# N5247AS-01A

# S E R V I C E N O T E

## N5247AS PNA Series Microwave Network Analyzers

**Some analyzers are exhibiting unlocked or unleveled errors or other unexpected digital control faults. Analyzers that experience any of the symptoms listed on page 2 of this document must be inspected for a possible return to Agilent to have the system motherboard replaced.**

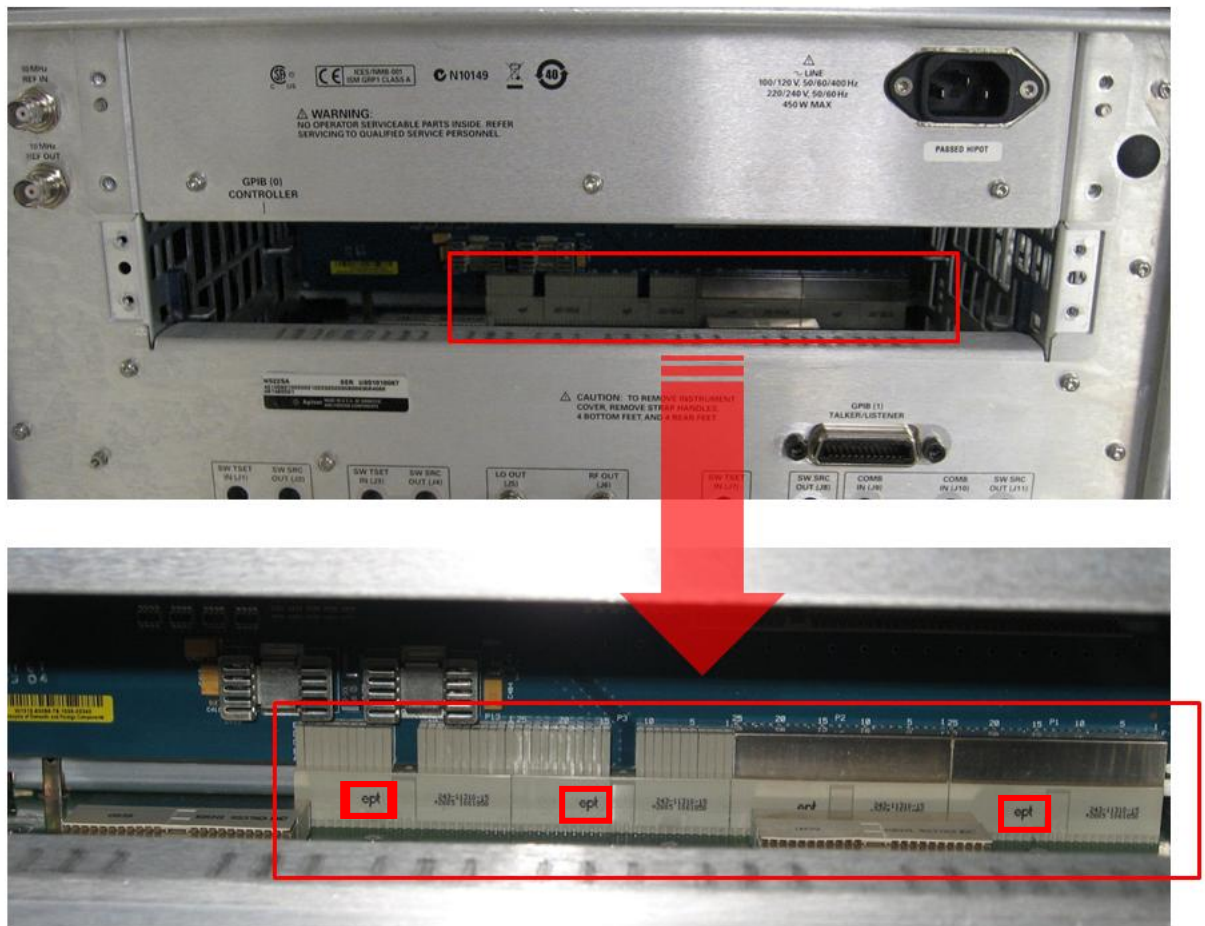
1. Remove the CPU assembly from the analyzer's rear panel. Refer to the PNA Service Guide chapter 7 section titled, "Removing and Replacing the CPU Board Assembly" for removal and reinstallation procedures. To view the online Service Guide, see the numbered list on the next page for instructions.
2. As per the photo below, inspect the system motherboard connector to see if it has one or more "ept" logos.

3. If the connector has one or more “ept” logos, return the analyzer to Agilent for replacement of the system motherboard. If the connector does not have one or more “ept” logos, email [ctd-soco\\_support@agilent.com](mailto:ctd-soco_support@agilent.com), providing the analyzer model and serial number and details of the malfunction symptoms.
